Your Ref: SSD-9653 Mod-4

**Comments on Section 4.55(2) Modification Application Concept Plan for a mixed use  
development within the Hills Showground Station Precinct  
3 Andalusian Way, Castle Hill**

# DEVELOPMENT ASSESSMENT PRE-LODGEMENT MEETING NOTES 32/2024/PRE – 1 December 2023

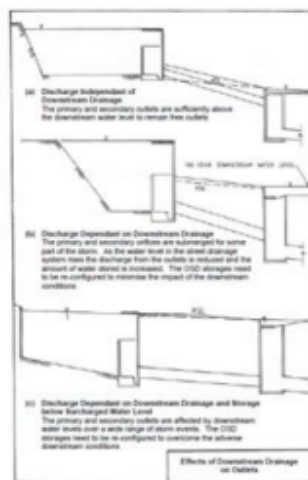
- Submerge outlet will be assessed once the revised civil/stormwater plans are received. However, it appears that the OSD is impacted by "Effects of Downstream Drainage on Outlets" which is not supported. The OSD configuration shall be redesigned. Please refer to Figure 6.3 of the On-site Stormwater Detention R3, of the Handbook Upper Parramatta River Catchment Trust, and the snapshots below:

Options "B and C" will not be supported, therefore, ensure the depth of the OSD is reduced and Options "B and C" are avoided.

With respect to the above, if the OSD outlet is impacted by drowned/submerge condition then the second column shall be used. Hence, the calculation will need to be revised.
